# SEQRA REVIEW FOR PROPOSED BULKELEY SCHOOLHOUSE OVERLAY ZONE

Village of Rhinebeck  
Village Board

January 23, 2024

TITLE:  
 PRELIMINARY OVERALL  
 SUBDIVISION UTILITY PLAN

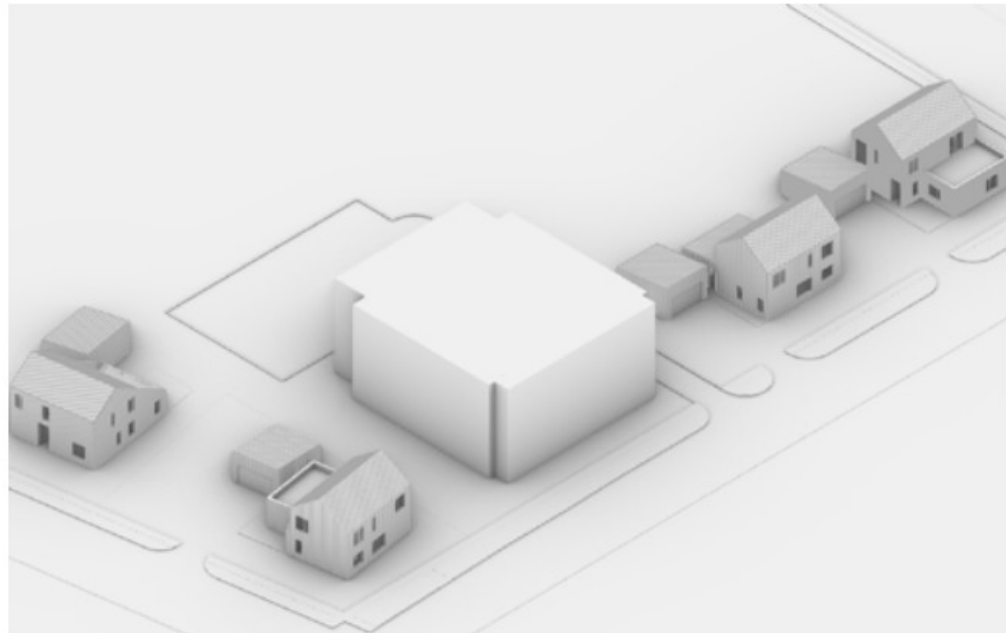
O.W.T.S. FIELD TESTING INFORMATION		
DEEP TEST HOLE DESCRIPTION	PERCOLATION RATE (MIN/IN)	R.O.B. GRAVEL FILL
DT-1: 0"-6" TOPSOIL; 6" TO 84" BROWN COARSE SAND WITH GRAVEL, NO GROUNDWATER OR LEDGE	PT-1 = 3 MIN/INCH PT-2 = 3 MIN/INCH PT-3 = 4 MIN/INCH PT-4 = 3 MIN/INCH PT-5 = 4 MIN/INCH PT-3 = 3 MIN/INCH  (DESIGN RATE = 1-5 MIN/INCH)	NONE
DT-2: 0"-6" TOPSOIL; 6" TO 84" BROWN COARSE SAND WITH GRAVEL & FRACTURES COBBLES, NO GROUNDWATER OR LEDGE		
DT-3: 0"-6" TOPSOIL; 6" TO 84" BROWN COARSE SAND WITH GRAVEL, NO GROUNDWATER OR LEDGE		
DT-4: 0"-6" TOPSOIL; 6" TO 84" BROWN COARSE SAND WITH GRAVEL, NO GROUNDWATER OR LEDGE		
DT-5: 0"-6" TOPSOIL; 6" TO 84" BROWN COARSE SAND WITH GRAVEL, DEBRIS ENCOUNTERED, HOLE LOCATION SHIFTED & RE-DUG NO GROUNDWATER OR LEDGE		
DT-6: 0"-6" TOPSOIL; 6" TO 90" BROWN COARSE SAND WITH GRAVEL, NO GROUNDWATER OR LEDGE

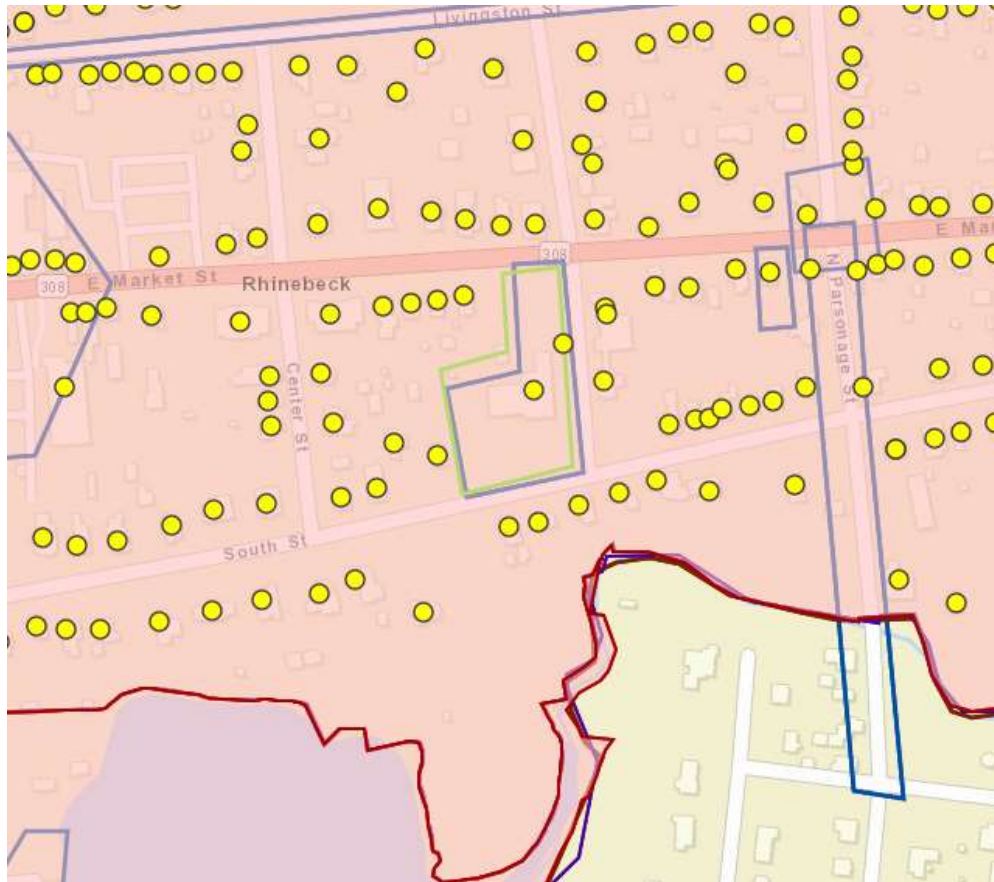
- Located in Historic District
- Bulkeley Schoolhouse is a contributing building to the Historic District
- Subject to Historic District Overlay Design Standards and Review
- Phase 1A/1B Archaeological Assessment Prepared – no archaeological findings
- NYS OPRHP SHPO Review in Progress for Historic Resources
- Neighborhood residents have asked the Village to consider design of homes in evaluation of impacts

NAVA 6 Mulberry Street Building Plan; 1<sup>st</sup> Floor, 2023

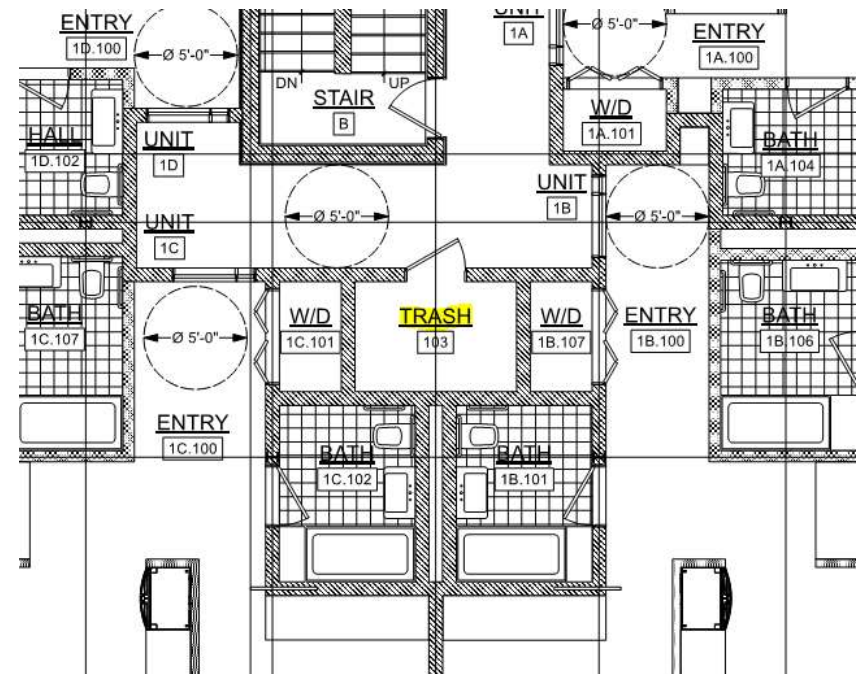
- Construction noise will occur
- Should be consistent with Village Standards
- Village can further limit construction hours if appropriate to reduce impact on neighborhood

- Rubbish collection consistent with residential use and same as neighborhood
- Interior collection; place at curb on pick up days

### Mirada Bollard (MRB) Low Level Lighting

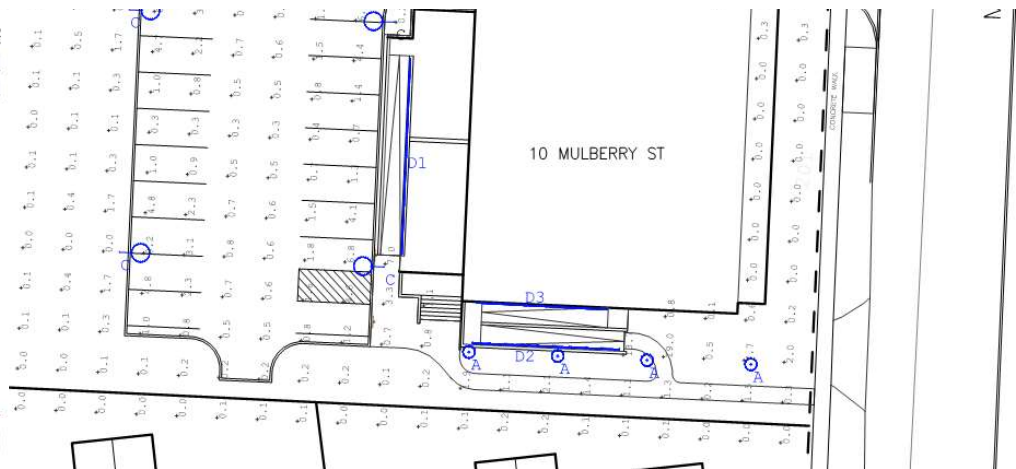
- Proposed BS-O requires development to “Minimize adverse impacts of illumination on neighboring lots
- Existing Zoning 120-18 will apply
- Village to consider other screening and visual mitigation measures
